Proposed Baseline text for:  
**Chip-to-chip 25 Gb/s one-lane  
Attachment Unit Interface  
(XXVAUI-1)**

Tom Palkert

Jan. 5 2015

# XXVAUI-1 Chip to Chip Channel

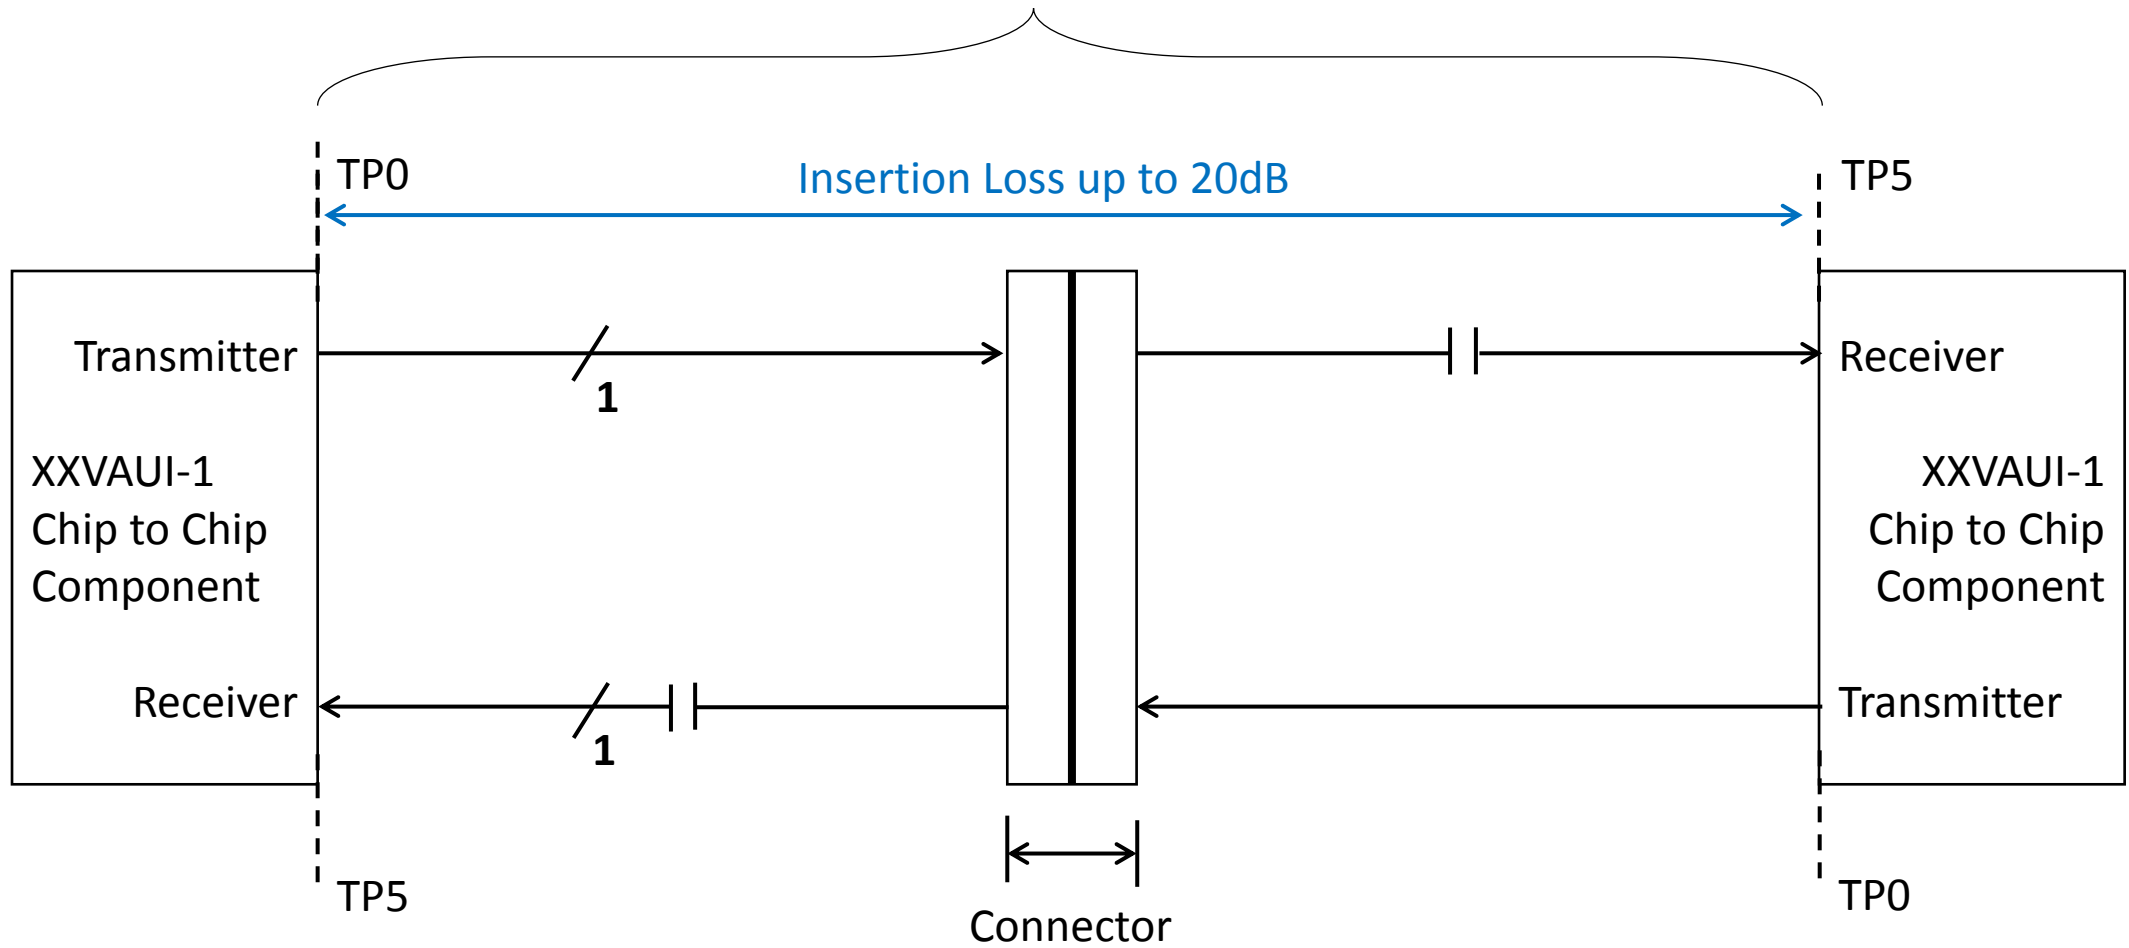
- Heavily leverages 802.3bm Annex X+4A (XXVAUI-1 Chip to chip)
  - Changes to Intro text
  - Changes to ISO diagram and application diagram
  - Changes to PICS pro forma 'protocol summary' and 'major capabilities/options' tables
  - All other sections referenced directly with change from '4 lane' to '1 lane'

The **XXVAUI-1** bidirectional link is described in terms of a **XXVAUI-1** transmitter, a **XXVAUI-1** channel, and a **XXVAUI-1** receiver. Figure **X+4A-2** depicts a typical **XXVAUI-1** chip to chip application,. The **XXVAUI-1** chip-to-chip interface comprises independent data paths in each direction. Each data path contains **one** differential lane which **is** AC coupled. The nominal signaling rate for each lane is 25.78125 GBd. The **XXVAUI-1** transmitter on each end of the link is adjusted to and appropriate setting based on channel knowledge. If implemented, the transmitter equalization feedback mechanism described in 83D.3.3.2 may be used to identify an appropriate setting. The adaptive or adjustable receiver performs the remainder of the equalization.
